**Addendum No. 1**

**Subject: J. Hampton Moore School  
Major Renovation Phase 2B – Interior Renovations  
SDP Contracts No. B-083C and B-084C of 2016/17**

**Location: J. Hampton Moore School  
1100 Tyson Avenue  
Philadelphia, PA 19111**

**This Addendum, dated 7th of November, 2017, shall modify and become part of the Contract Documents for the work of this project. Any items not mentioned herein, or affected by, shall be performed strictly in accordance with the original documents.**

**2** TYPICAL CLASSROOM - STANDARD DETAIL  
1/4" = 1'-0"

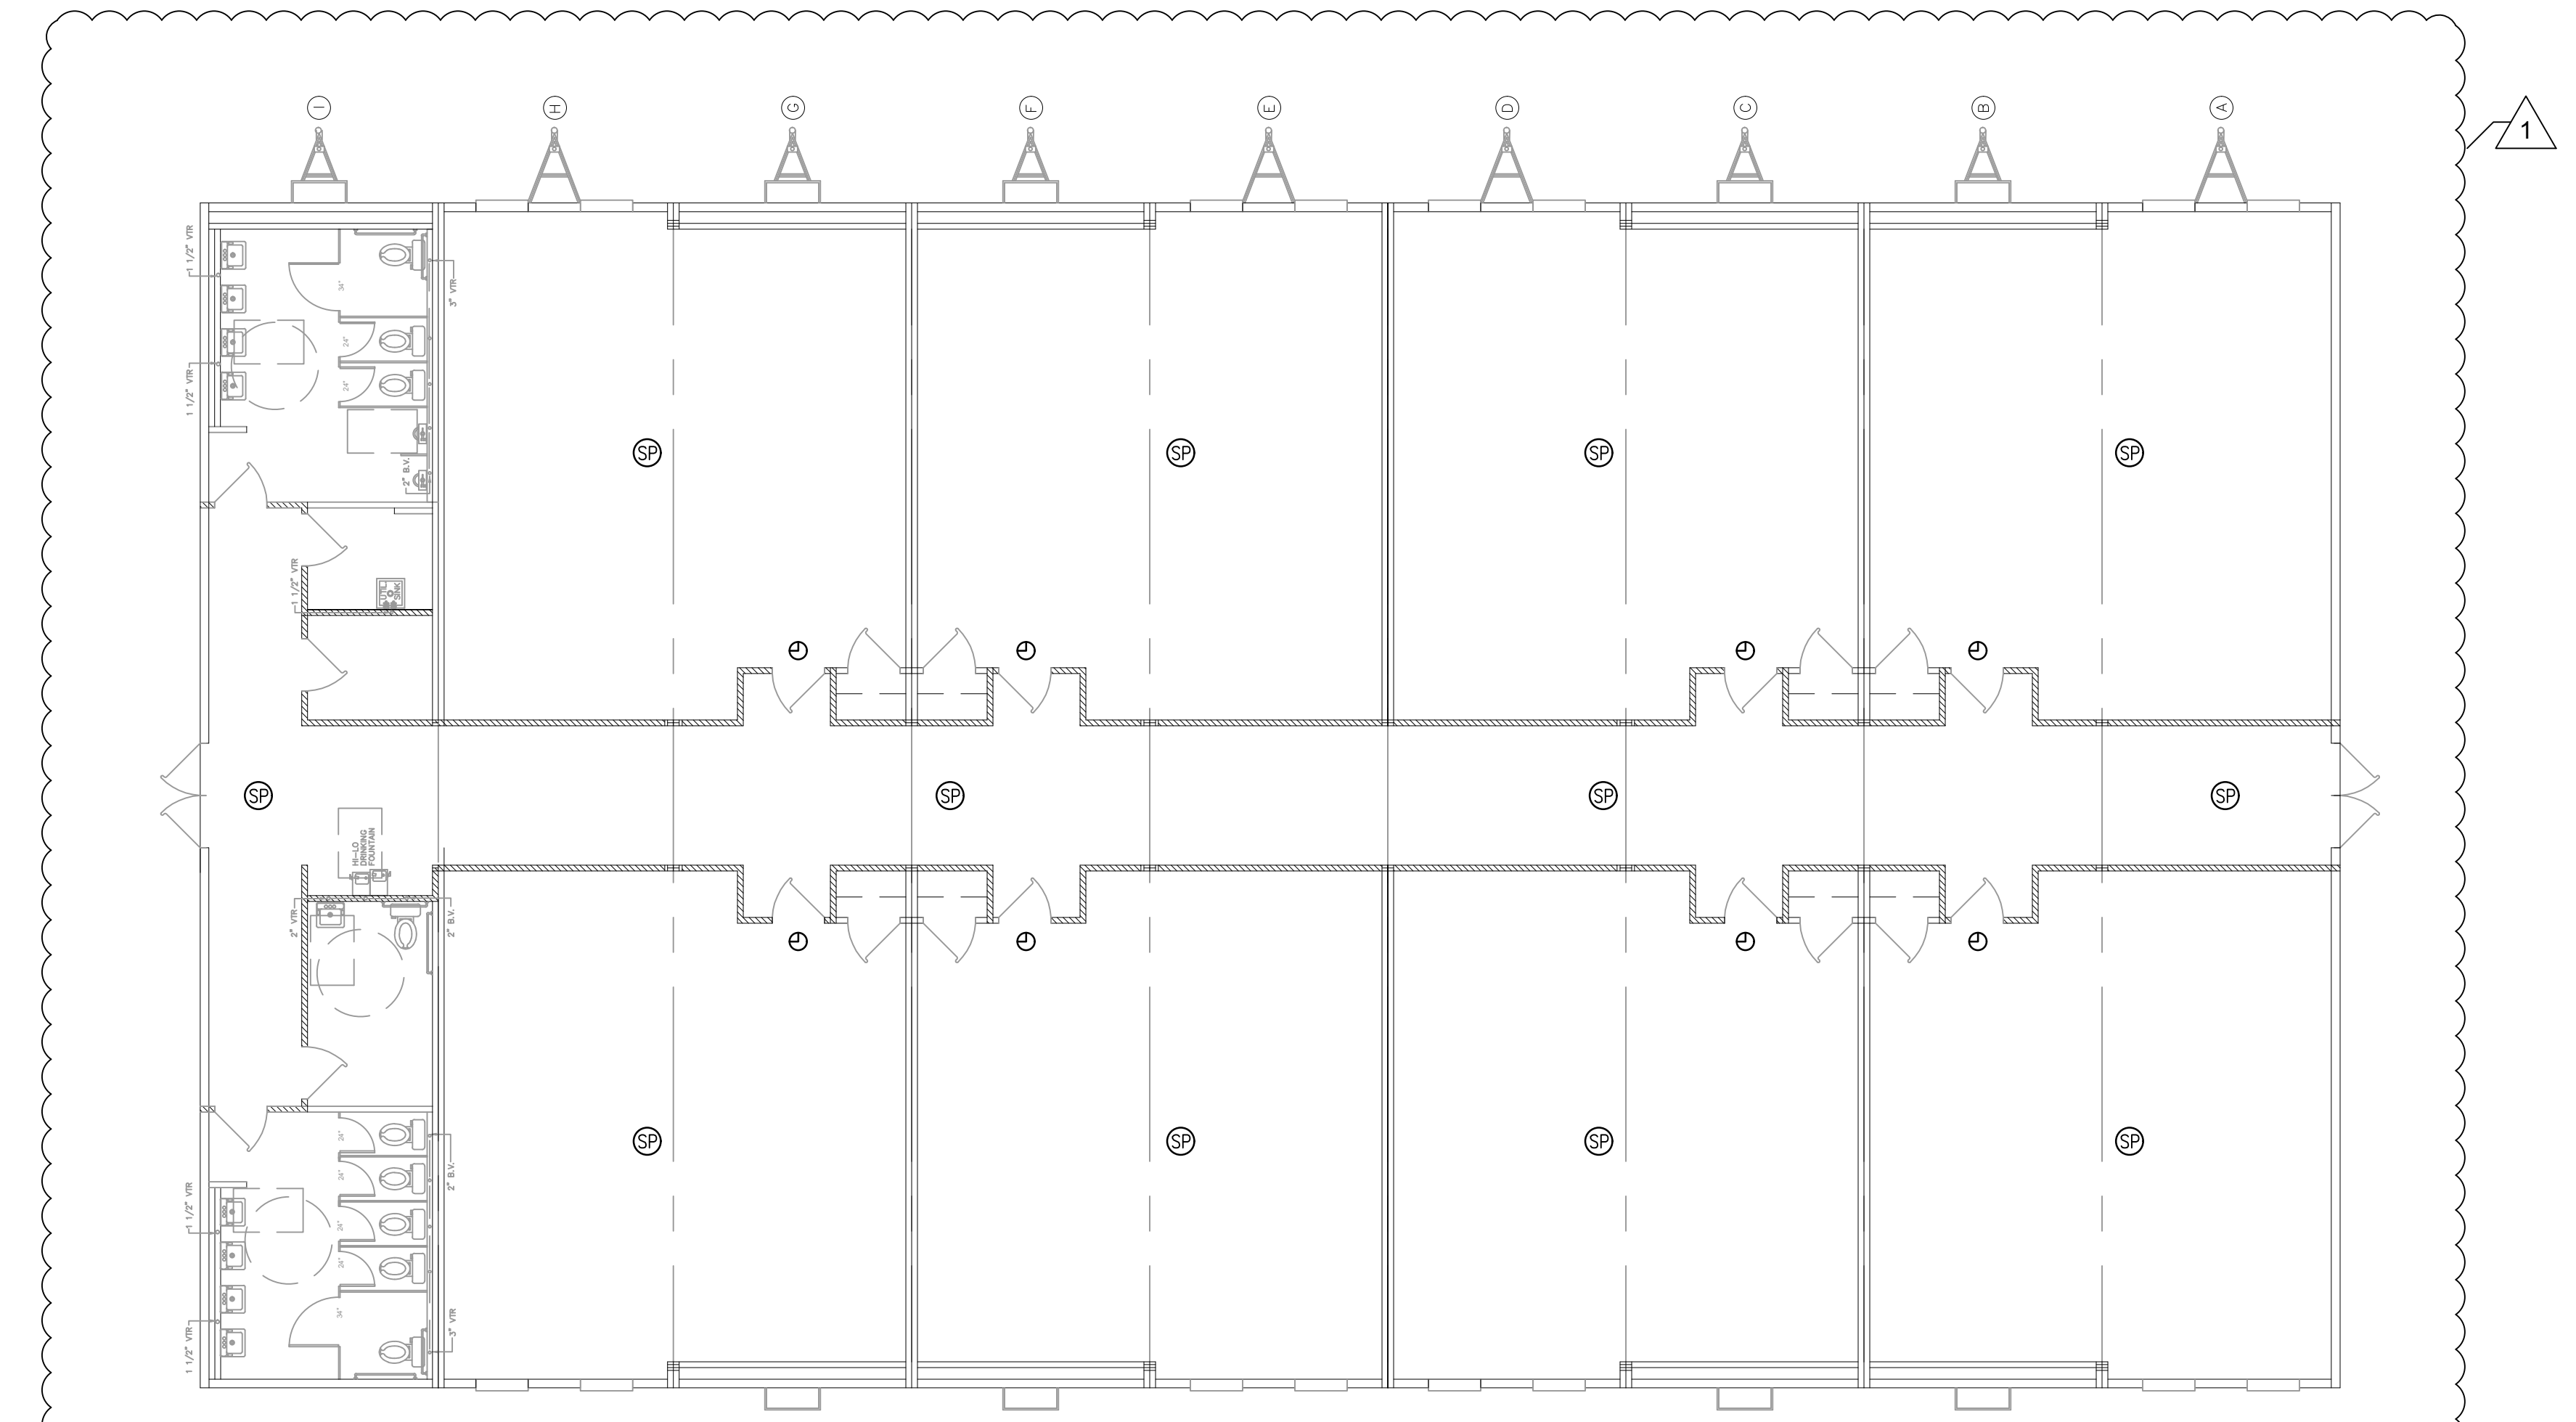
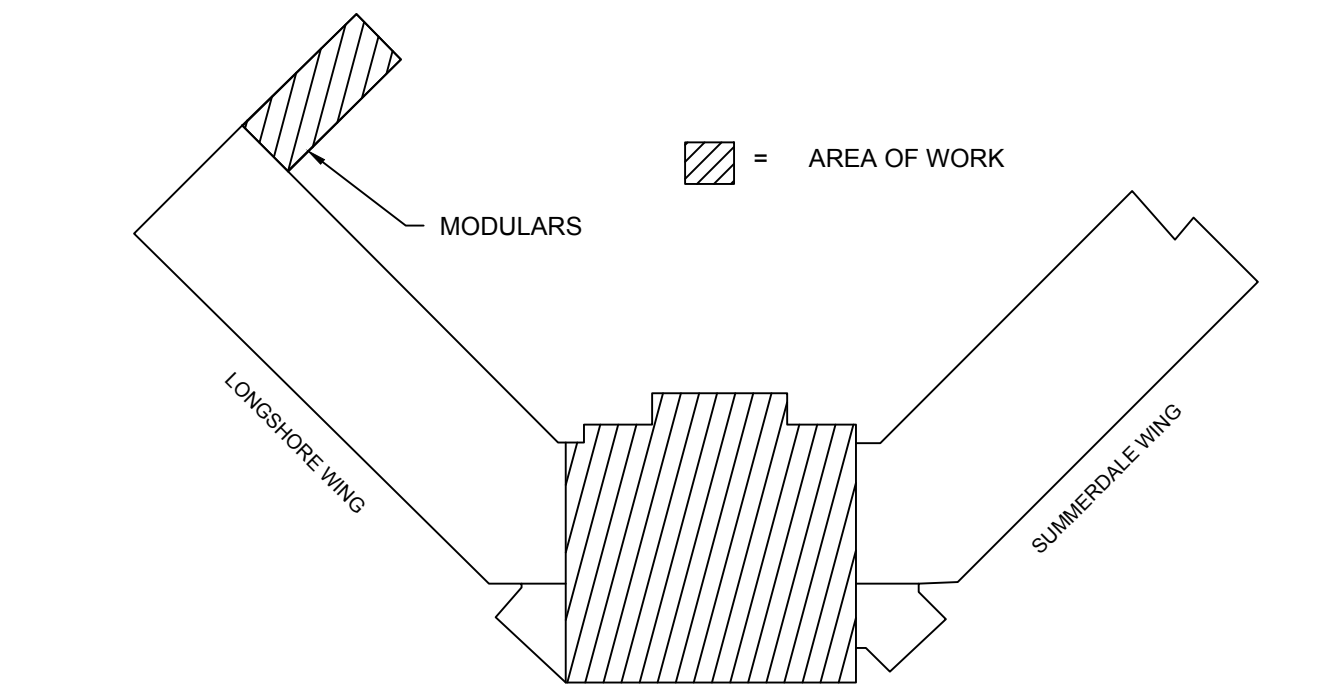
- 1. Drawing E2.02 is revised to include PA speakers and wireless clocks in the new modular building. The modular building is provided by others and is not part of this project.**
- 2. Drawing E5.04 – Detail 3 mounting detail is modified to include power/control cable.**
- 3. Drawing E6.01 – PNL L main rating changed to 225A; PNL L breaker at MDP2 changed to 175A; feeders from MDP2 to PNL L changed to 4 #2/0 & 1-#6 Gnd.**
- 4. Drawings FA.01 thru FA.04 – Notification circuit power booster (NAC) added to symbol legend; Location of NAC have been indicated on plans; Note 4 and 6 have been modified.**

- MODULAR ELECTRICAL PLAN NOTES:**
- MODULAR BUILDING IS BY OTHERS. SCOPE OF WORK IS FOR SPEAKERS AND WIRELESS CLOCKS ONLY.
  - FOR EACH SPEAKER, PROVIDE 20 OR 22 AWG SOLID SHIELDED SPEAKER CABLE, HOME RUN DIRECTLY BACK TO THE MODULAR IDF AND TERMINATE ON A 66 BLOCK. CONTRACTOR SHALL PROVIDE THE 66 BLOCK WITH PROSPECTIVE TERMINALS.
